doc.: IEEE 802.15- 15-11-0166-02-004g

Submission Title: Cognitive Spectrum Management (CSM) Signaling Options

Abstract: Comment Resolution

Comments # 53,54,55,67,70,72,73

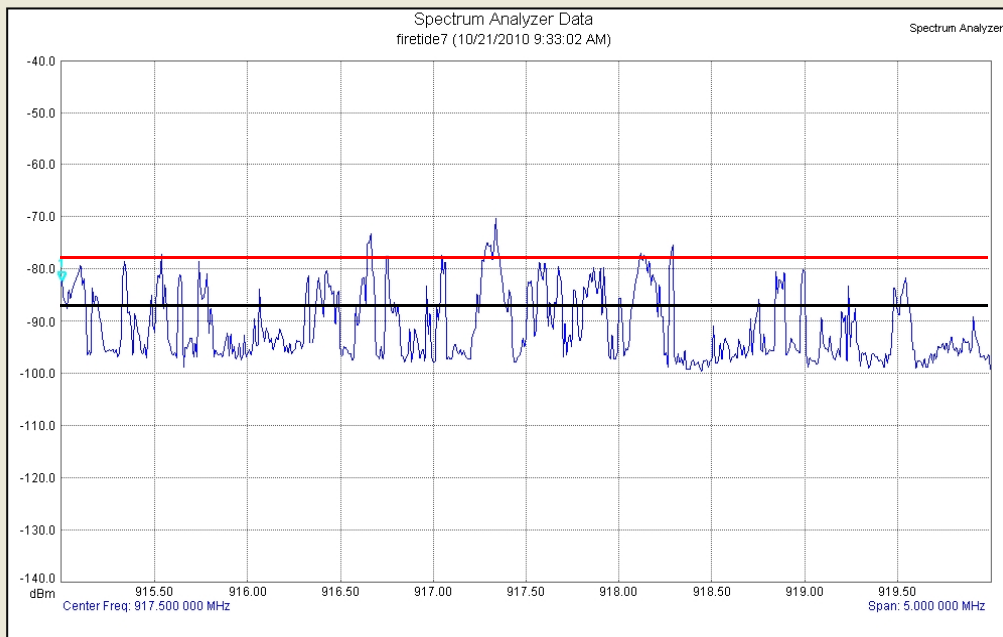
Comment Resolution

Add the following text to the TG4G draft
in the appropriate locations

- Number of CSM channels = Floor (Valid channels / 16)
- Ch # = X(floor (((Max Valid Channel -1) – (Min Valid Channel +1) / N))
- IF MPM used EBI duration = N (EBR duration + Delay) ²
- EBR consist of 512 bits
- EBR transmitted at 50 kbps
- Settling Delay is 1.28 uS
- Add text and illustrations from slides 6-9 of doc 802.15-15-11-166-01 to draft to define the non-beacon enabled co-existence mechanism
